REVISED RESPONSE TO REQUEST FOR ADDITIONAL INFORMATION

APR1400 Design Certification

Docket No. 52-046

RAI No.: 116-8054
SRP Section: 14.03.08 – Radiation Protection Inspections, Tests, Analyses, and Acceptance Criteria
Application Section: Tier 1, Various Sections
Date of RAI Issue: 07/27/2015

Figure 2.7.2.5-1 Equipment and Floor Drainage System

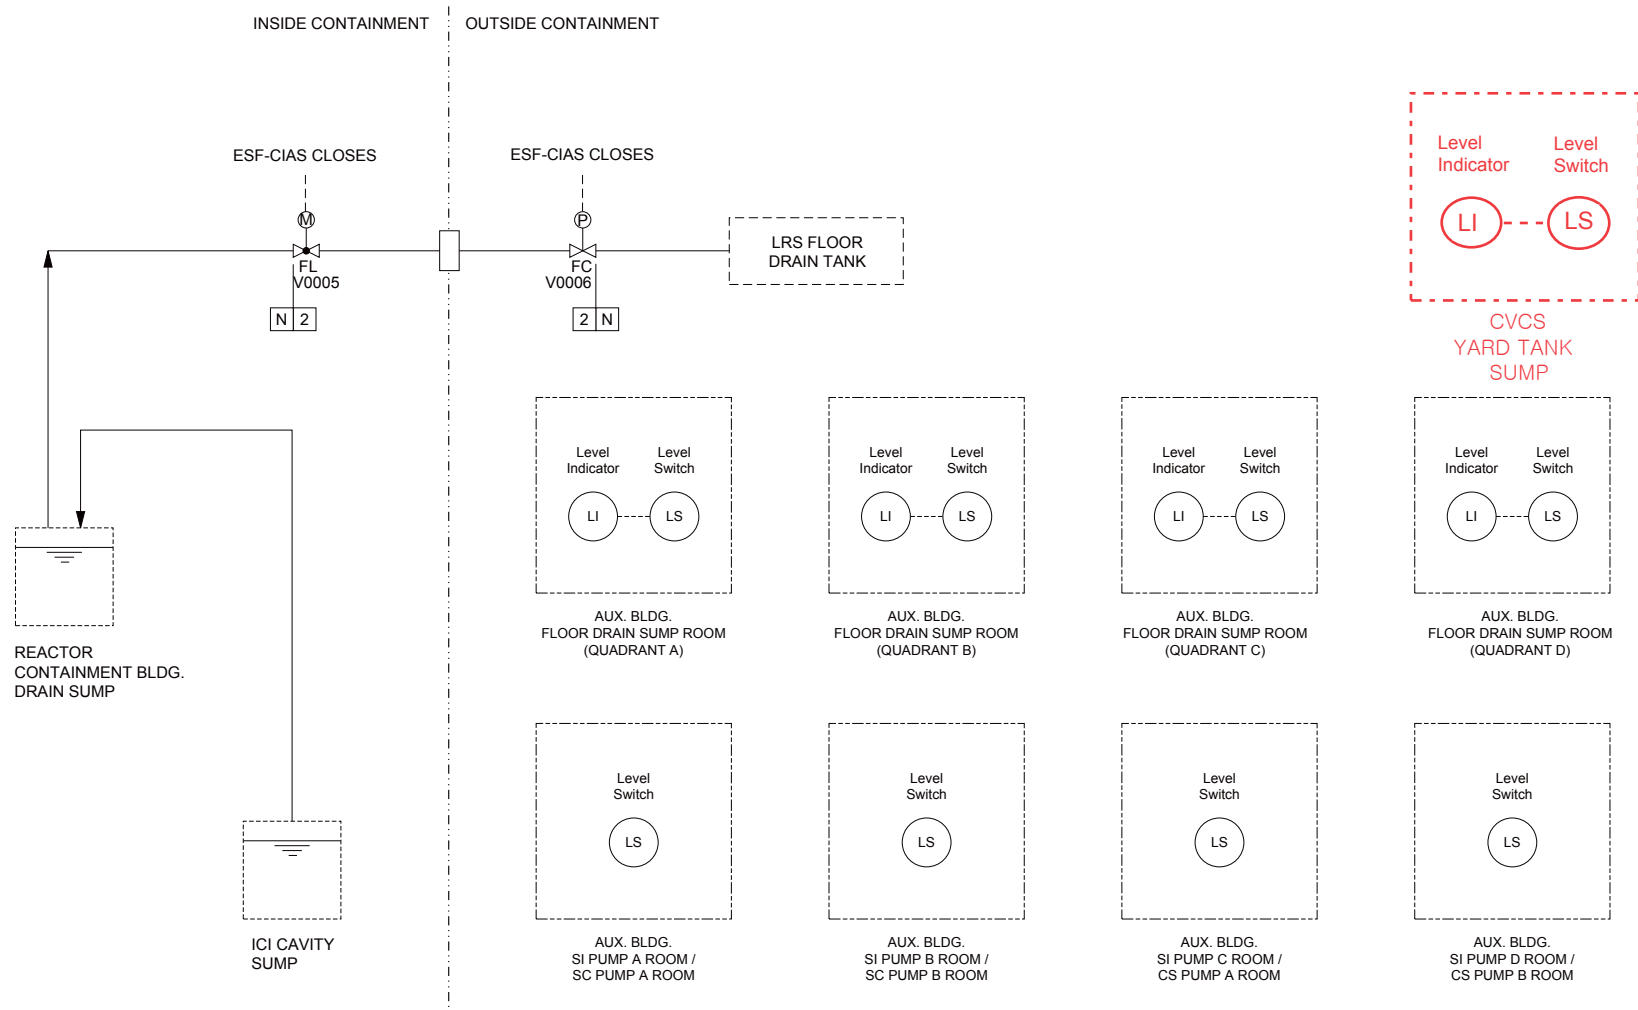
In reviewing Tier 1 ITAAC, staff could not find any ITAAC for design features to minimize contamination. In accordance with 10 CFR 20.1406(b), please provide ITAAC for significant design features to address leaks from high specific activity fluids (such as Reactor

Coolant System water, Spent Fuel Pool coolant or concentrated liquid waste) or from high volume, low specific activity fluids (such as diluted liquid radioactive waste).

CVCS is designed to comply with 10 CFR 20.1406 as discussed in DCD Tier 2 Subsection 9.3.4.2.10. The holdup tank, boric acid storage tank (BAST), and reactor makeup water tank (RMWT) are located outside in a tank house which is designed with a sloped floor coated with epoxy to facilitate draining and cleaning. The tank house is equipped with a sump that contains level switches to detect leakage and overflow. This leak detection design feature is considered significant and additional ITAAC will be added to DCD Tier 1 Subsection 2.7.2.5 Table 2.7.2.5-4 as presented in Table 3 below.

Design Commitment	Inspections, Tests, Analyses	Acceptance Criteria
9. Leak detection design for the tank house sump for holdup tank, BAST and RMWT provides an alarm in MCR of liquid detection	9. Inspection of the as-built leak detection system and signal test is conducted to verify the alarm in the MCR.	9. The as built leak detection instrumentation is installed as designed; and the alarm is verified in the MCR.

9. Leak detection design for the tank house sump for holdup tank, BAST, and RMWT provides an alarm in MCR of liquid detection	9. Inspection of the as-built leak detection system and signal test is conducted to verify the alarm in the MCR.	9. A report concludes that the as-built leak detection is installed as designed; and concludes that the alarm is consistent with the setpoint.
---	--	---

The as built leak detection instrumentation is installed as designed; and the alarm is verified in the MCR
